City of Nedlands

AGENDA

28 June 2022

16.1 PD35.06.22 Consideration of Development Application – 4 Grouped Dwellings at 24 Clark Street, Nedlands 9
16.2 PD36.06.22 Comment on State Development Assessment Unit Application for Children's Hospice Development at 61 (Lot 503) Clement Street, Swanbourne 18

DWG TITLE: SITE PLAN

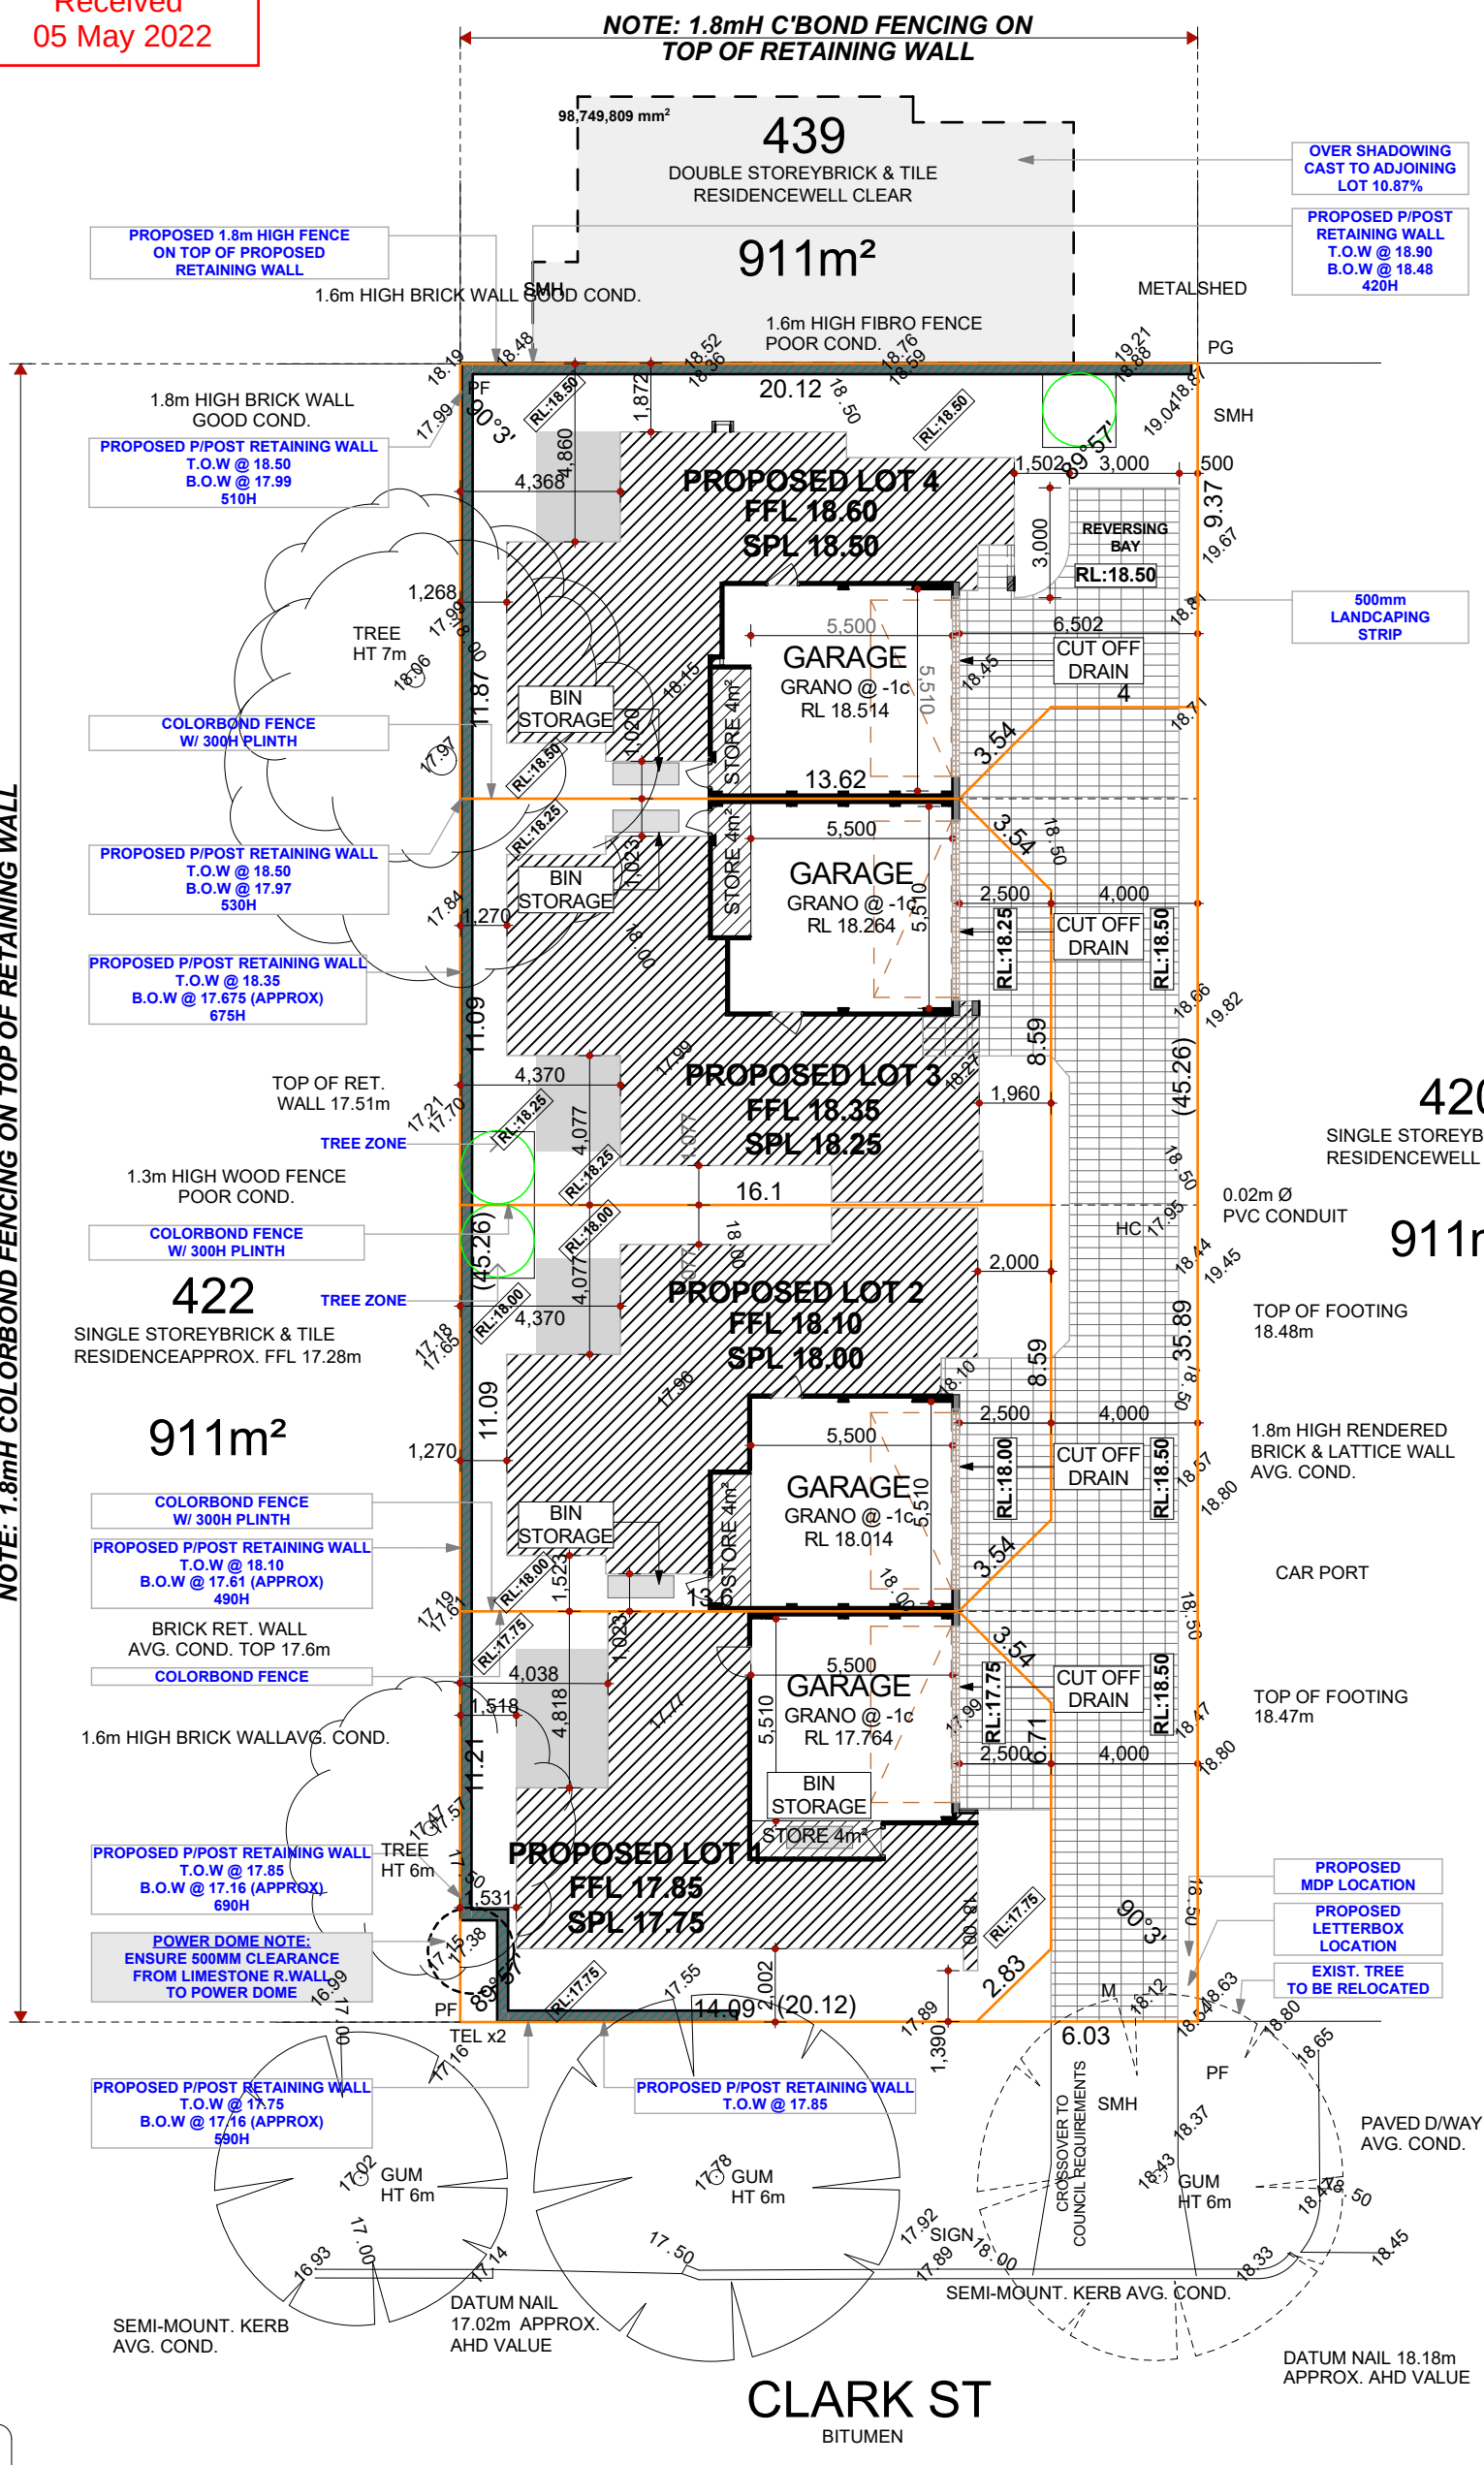
Question
Councillor Mangano – Can the need for retaining on western side of the block be obtained?

Officer Response
The provision of 500mm of landscaping area adjacent to the existing masonary fence, the proposed level of the driveway and discussions with the applicant have resulted in officers concluding that retaining in this location does not need to be shown on the plans.

LANDSCAPE PLAN

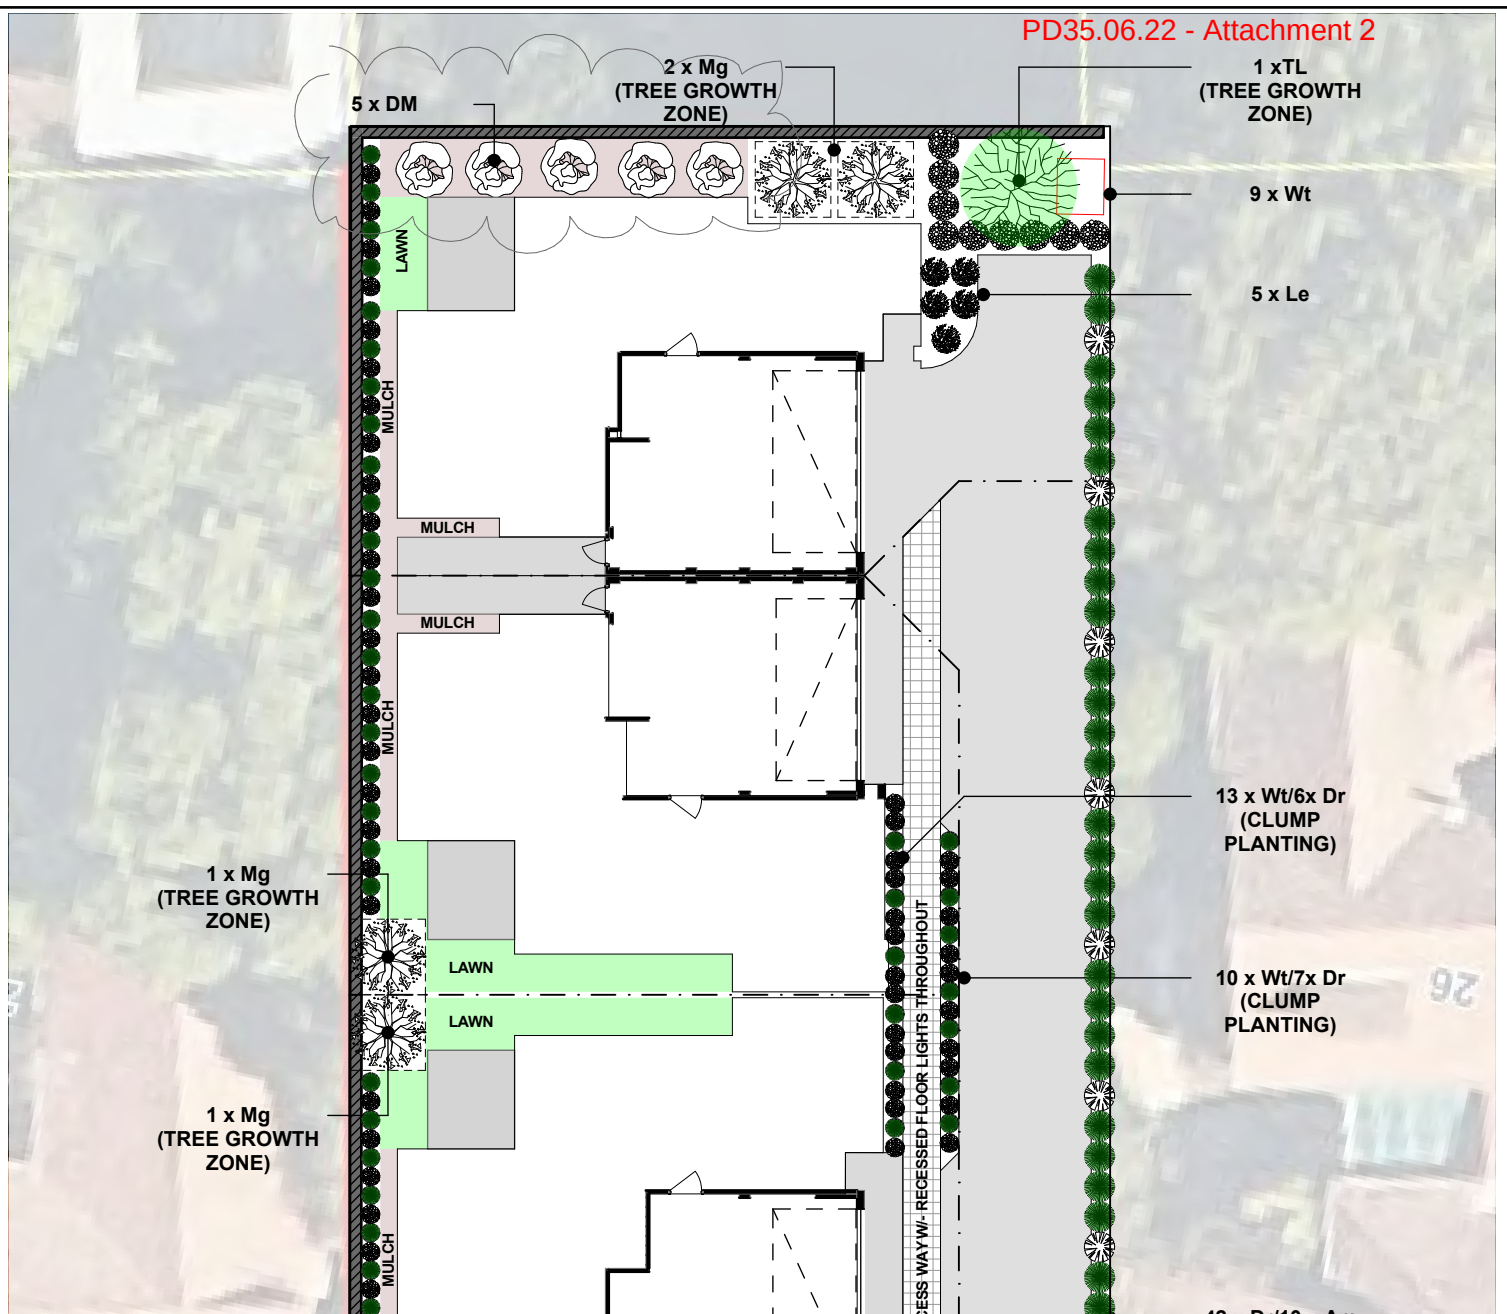
Question
Magnolias listed on landscape plan when outlined all plants are native, can this requirement be clarified?
